WASHINGTON STATE  
DEPARTMENT OF TRANSPORTATION  
CHANGE ORDER

CONTRACT NO: 009587 FEDERAL AID NO:  
CONTRACT TITLE: US 395, NSC SPOKANE RIVER TO COLUMBIA  
CHANGE ORDER NO: 36 BNSF FENCE

This Change Order adjusts quantities and adds new Bid Items to the Contract for permanent Burlington Northern Sante Fe (BNSF) Right of Way Fence to meet BNSF requirements.

**BNSF FENCE DETAIL A (NTS)**

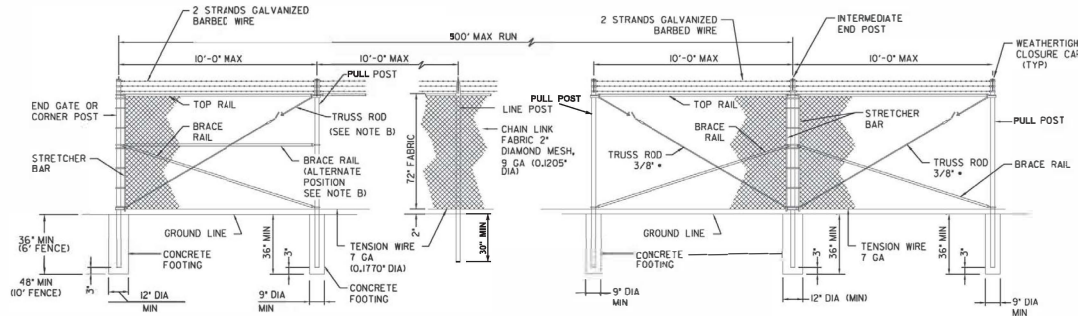
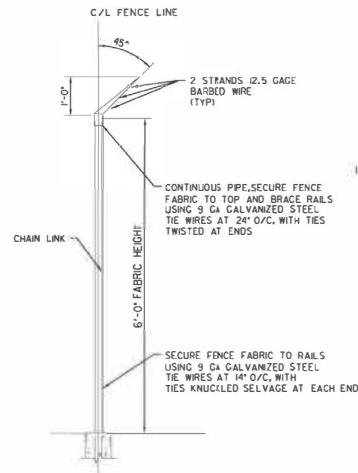
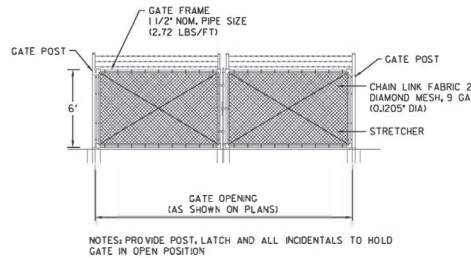
All materials for "BNSF Fence Items" shall meet the requirements as shown in the general notes section of added sheet PV16A. All other materials shall meet the requirements of the contract.

All Work on "BNSF Fence Items" shall be in accordance with the general notes section of added sheet PV16A. All other Work shall meet the requirements of the contract.

- (1) ALL POSTS SHALL BE PLUMB AND ALIGNED.
- (2) CHAIN LINK FABRIC TO BE STRETCHED AND FASTENED TO POSTS @ 14" MAX CENTERS AND PIPE RAILS @ 24" MAX CENTERS.
- (3) FITTINGS SHOWN ARE ILLUSTRATIVE OF USE AND NOT SPECIFIC AS TO DESIGN.
- (4) KNUCKLE SELVAGE AT TOP AND BOTTOM.
- (5) GATE POSTS ON EACH SIDE OF A GATE OPENING TO BE THE SAME SIZE, AT A DOUBLE GATE INSTALLATION WITH UNEQUAL WIDTH GATES, SIZE OF BOTH POSTS TO BE AS INDICATED FOR A SINGLE GATE INSTALLATION OF THE WIDER WIDTH GATE.
- (6) PROVIDE POST, LATCH AND ALL INCIDENTALS TO HOLD GATE IN OPEN POSITION.
- (7) FOR CROSS SECTIONAL DIMENSIONS OF MEMBERS, SEE TABLE 1.
- (8) SET POSTS VERTICALLY AND IN TRUE ALIGNMENT. THE NEW FENCE SHALL BE PERMANENTLY TIED TO THE TERMINALS OF EXISTING FENCES WHEN REQUIRED BY THE ENGINEER.
- (9) DO NOT ERECT FENCE UNTIL THE CONCRETE ENCASEMENT AROUND THE POSTS HAS CURED FOR AT LEAST 3 DAYS.

- (13) INSTALL CORNER POST WHERE THE ANGLE OF DEFLECTION OF THE FENCE LINE IS GREATER THAN 15 DEGREES.
- (14) PLACE CHAIN LINK FABRIC BY SECURING ONE END TO THE END POST AND APPLYING SUFFICIENT TENSION TO REMOVE ALL SLACK BEFORE MAKING ATTACHMENTS ELSEWHERE. AFTER THE FABRIC HAS BEEN STRETCHED, TIE IT TO THE TENSION WIRE WITH FABRIC TIES SPACED NOT MORE THAN 24 INCHES APART. THEN ATTACH THE FABRIC TO THE LINE POSTS WITH FABRIC TIES SPACED NOT MORE THAN 14 INCHES APART. PROVIDE STANDARD CHAIN LINK FENCE STRETCHING EQUIPMENT FOR STRETCHING THE FABRIC BEFORE TYING IT TO THE TENSION WIRE AND POSTS. REPEAT STRETCHING AND TYING OPERATIONS ABOUT EVERY 100 FEET UNTIL THE RUN OF FENCE IS COMPLETED.

- (15) GRADE ALL HIGH POINTS WHICH INTERFERE WITH THE PLACEMENT OF THE WOVEN WIRE OR CHAIN LINK FABRIC TO PROVIDE NO MORE THAN 2 INCHES OF BOTTOM CLEARANCE OR AS SHOWN ON THE PLANS.

- (17) HANG GATES ON GATE FITTINGS AS SHOWN ON THE PLANS. ADJUST HINGES AND DIAGONAL BRACING IN GATES SO THAT GATES WILL HANG LEVEL. ERECT GATES IN SUITABLE PLACES AS DIRECTED BY THE ENGINEER OR AS SHOWN ON THE PLANS.

- (18) WHEREVER A NEW FENCE JOINS AN EXISTING FENCE, EITHER AT A CORNER OR AT THE INTERSECTION OF STRAIGHT LINE FENCE, SET A CORNER POST WITH BRACE AT THE JUNCTION AND BRACE THE SAME AS DESCRIBED FOR CORNER POSTS OR AS SHOWN ON THE PLANS.

**BNSF AR 1 ROADWAY SECTION 2**

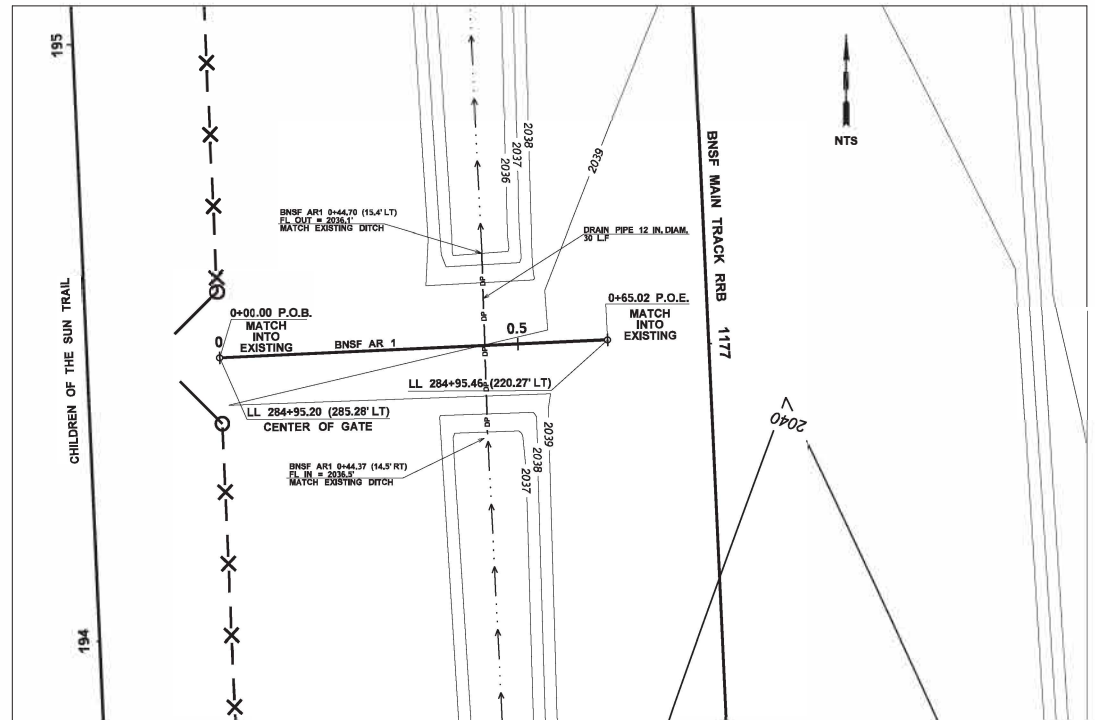
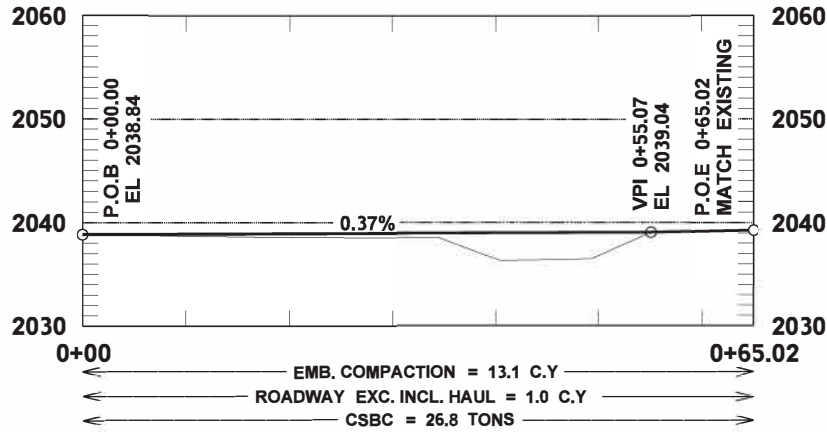
BNSF AR1 P.O.B 0+00.00 to 0+65.02 P.O.E  
BNSF AR1 0+43.95 to 0+44.95 \*DRAIN PIPE EXCEPTION (SEE ROADWAY SECTION 2)

\*DRAIN PIPE EXCEPTION  
DRAIN PIPE 12 IN. DIAM (30 LF)  
MATCH EXISTING FLOWLINES SHOWN ON PLAN VIEW BELOW

### BNSF AR 2 ROADWAY SECTION

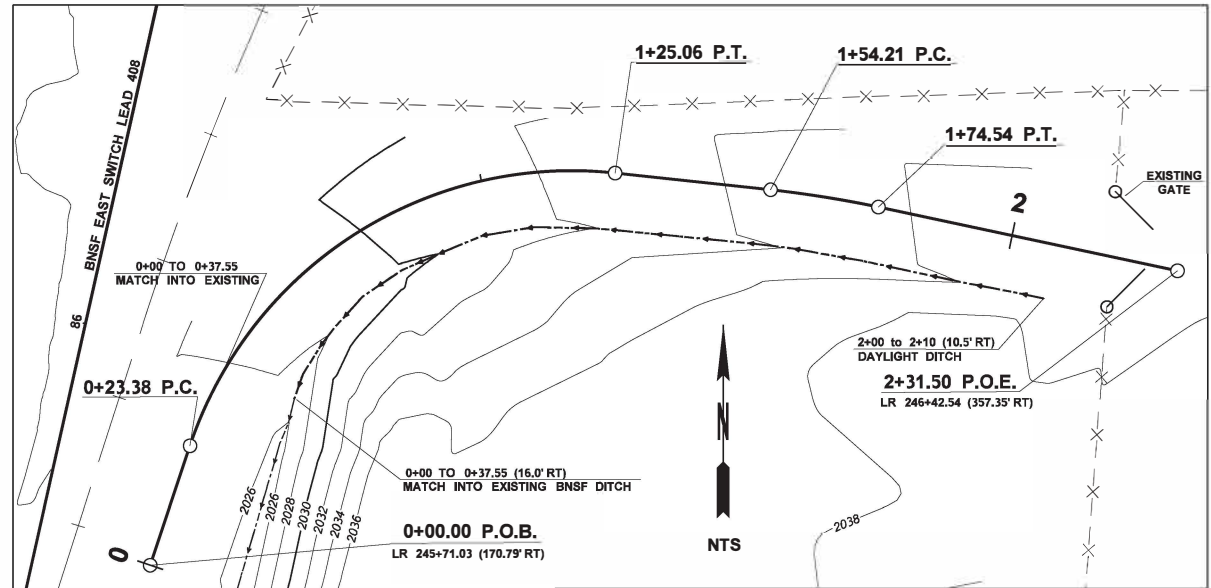
BNSF AR2 0+37.55 TO 2+31.50  
\*BNSF AR2 0+37.55 MATCH INTO EXISTING DITCH (SEE PLAN VIEW)  
\*BNSF AR2 2+00 TO 2+10 DAYLIGHT DITCH (SEE PLAN VIEW)
